DDA Consultant Advice Memo

To: Taronga Zoo – Kristine Marshall
From: Paul O’Shannassy
Date: 07.04.2021
Project: Taronga – Upper Australia Refurbishment
MSA Ref: MSA2080_DDA_Memo1

Re: Upper Australia SSDA Modification - Accessibility (DDA) review of revised dingo exhibit pathway & southern link

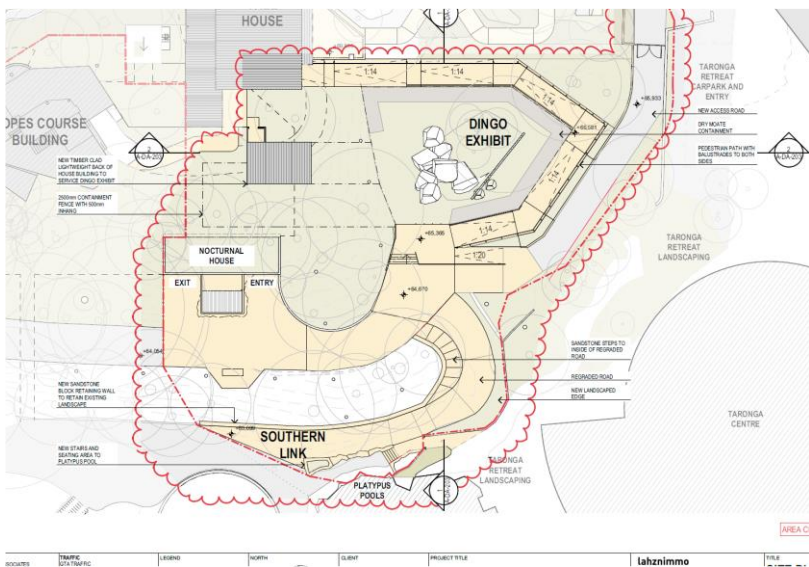
Dingo Exhibit Pathway – Compliance Comments & Recommendations

The pathway is directly associated with the dingo exhibit and although not forming a 'building' (for the purposes of BCA compliance) is recommended by MSA to be 'accessible' (i.e. generally complying with AS1428.1).

The pathway primarily comprises a series of ramps and landings (with additional stairs and a 1:20 'walkway' provided to the south).

The location, grades and dimensions of the ramps (& stairs/walkway) are generally compliant with AS1428.1 & therefore deemed 'accessible'.

Further details would typically be provided during detailed design stage to include:

- Handrails – accessible handrails required to both sides of stairs and ramps
- Kerb rails/Kickplates – required to the sides of ramps & walkways
- Tactile Ground Surface Indicators (TGSI's) – required to top and bottom of ramps and stairs (noting that TGSI's are not required to mid landings where a continuous handrail is provided).
- Stairs details - solid risers & contrasting non-slip nosing strips
- Floor surfaces (of ramps and landings) – to be non-slip and traversable by wheelchair

Southern Link

The works proposed to the existing 'southern link' generally involved the widening & repositioning of the path resulting in an overall shallower grade.

It is noted that this area serves as a pedestrian link between levels of the zoo, but is not considered to be directly associated with a particular 'building' and as such not considered to attract the accessibility requirements of the BCA or 'Access to Premises Standards' (similar to a public footpath in this regard).

Notwithstanding, the proposed works will improve general accessibility including pram access.

General (advisory) recommendations to be considered include:

1. Provision of handrails, kerbrails
2. Provision of slip resistance path surface
3. Seating for rest
4. Lighting above the pathways
